SITE BASED STORMWATER MANAGEMENT PLAN

Proposed Developments at
62 KRAFT RD, 69 & 73 KRAFT RD AND 136 & 152 LAXTON RD PALLARA
for
ADC GROUP NO 12 PTY LTD & ADC GROUP NO 15 PTY LTD

B3602EA7_DA19_SBSMP – Revision C
 May 2026

Revision	Date	Details	Prepared By	Approved By
A	29/08/2022	For Client Review & Authority Submission	CB (RPEQ 19190)	TMcK (RPEQ 5087)
B	28/07/2025	Revised development strategy	CB (RPEQ 19190)	TMcK (RPEQ 5087)
C	08/05/2026	Council Information Request Responses	 CB (RPEQ 19190)	 SM (RPEQ 8068)

Figure 2 – Proposed Field Inlet (Schematic Only)

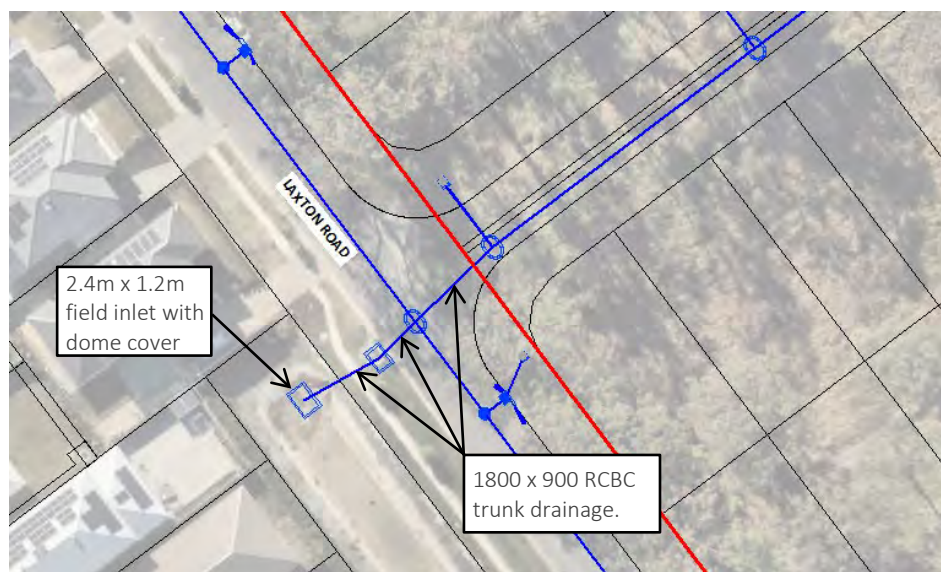
6. *Flood model must be amended to include:*
- *The trunk pipe on Laxton Road must connect to the existing concrete channel via a new large inlet to capture as much of the 10% AEP flow as possible. Provide model inlet capture details on that inlet.*

- *The impact on Laxton Road as a result of this development needs to be reduced as the access to the site is through this road connection. This road should provide a suitable standard of service. A new inlet may help reduce the impacts.*

- A field inlet with a minimum 2.4m x 1.2m opening is proposed at the end of the existing concrete channel. Refer to **Appendix I** for inlet capture modelled and **Figure 2** for the schematic.
- The results showed improvements on Laxton Road in a 10% AEP however it did not notably reduce the flood level impacts in a 2% AEP storm event. Still, the 2% AEP flooding on Laxton Road complies

with the QUDM (2016) as the flood depths do not exceed 300mm and DV products do not exceed $0.4\text{m}^2/\text{s}$. Refer to **Section 4.4.4** for further details.

Figure 16 – Sensitivity Scenario 1, 2% AEP Overland Flow

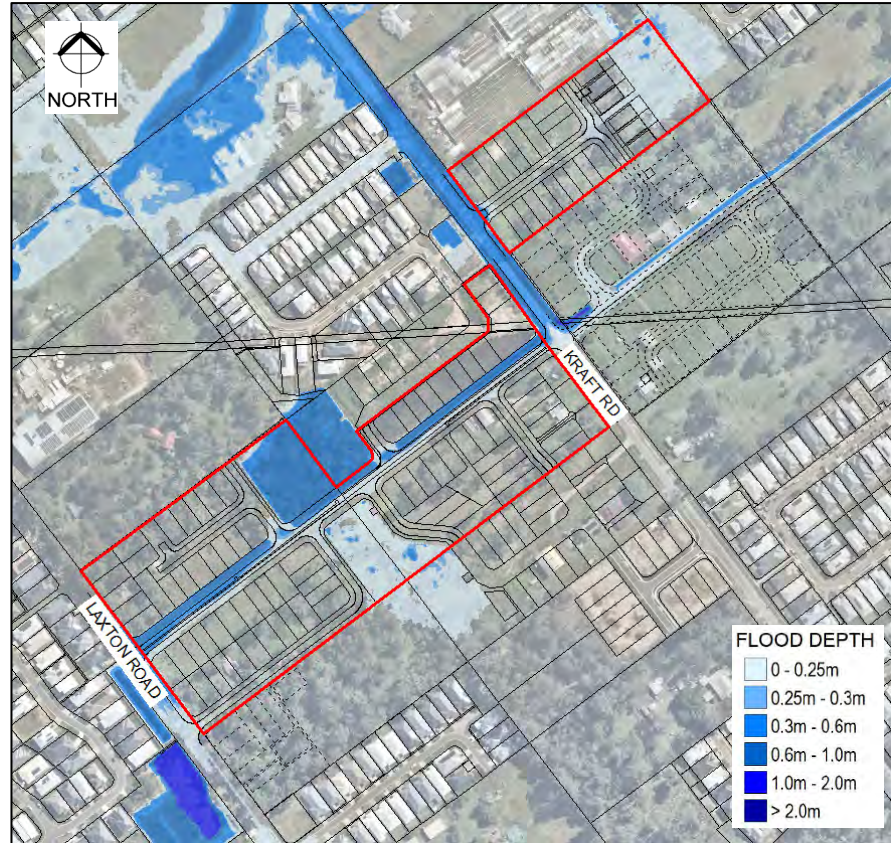
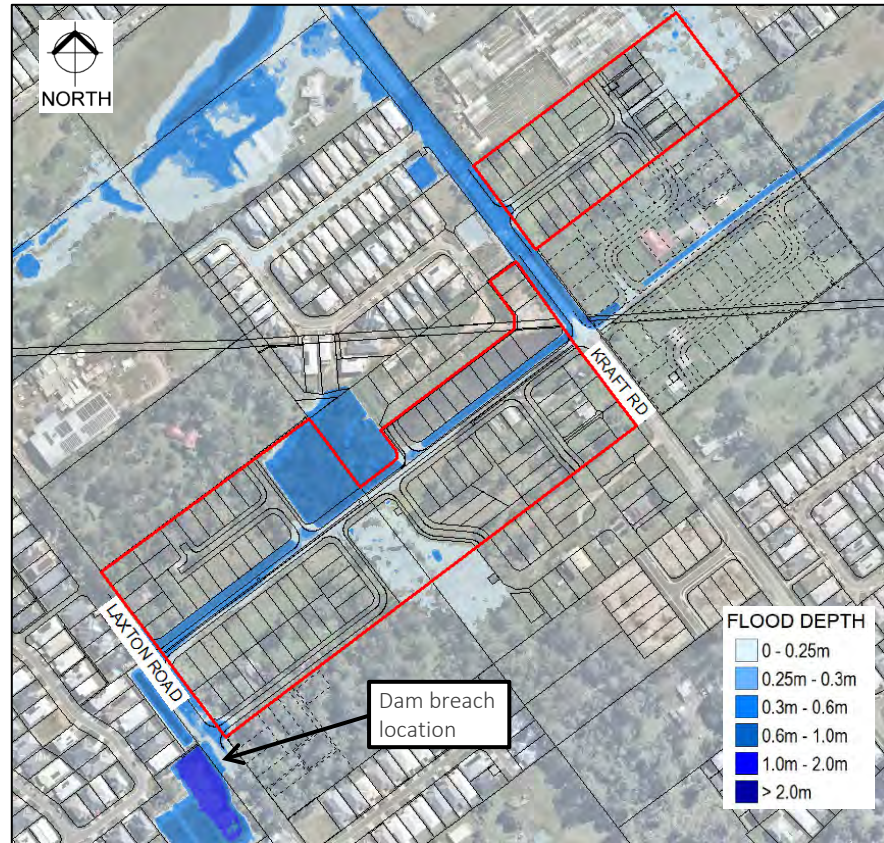
- *The sensitivity scenario shall include AR&R climate change provisions, especially as it is downslope of a dam. This could be a simple factoring up of 1987 IFD used in the hydrology*

1. *The flood analysis sensitivity scenario is required to include AR&R climate change provisions, especially as it is downslope of a basin. This could be a simple factoring up of the 1987 IFD used in the hydrology in accordance with SSP2-4.5. It must be ensured that new lots do not flood as a result of this sensitivity scenario. In addition, sensitivity analysis should include the risk to adjacent lots on Laxton Road and lots along the new neighbourhood road in the case of a dam failure.*

RESPONSES TO ITEM 1: Refer to **Section 4.6** for the 2% AEP sensitivity scenarios. The results confirm that the new lots remain flood free with climate change provisions. The results further confirm that the new lots on Laxton Road remain flood free in the case of a dam failure.

The 2% AEP flooding is shown on **Figure 16** and **Figure 17**. As can be seen all new lots remain flood free. It is further noted that the applicant's typical slab height for lots is 450mm. The dwellings will therefore have well above the minimum freeboard required.
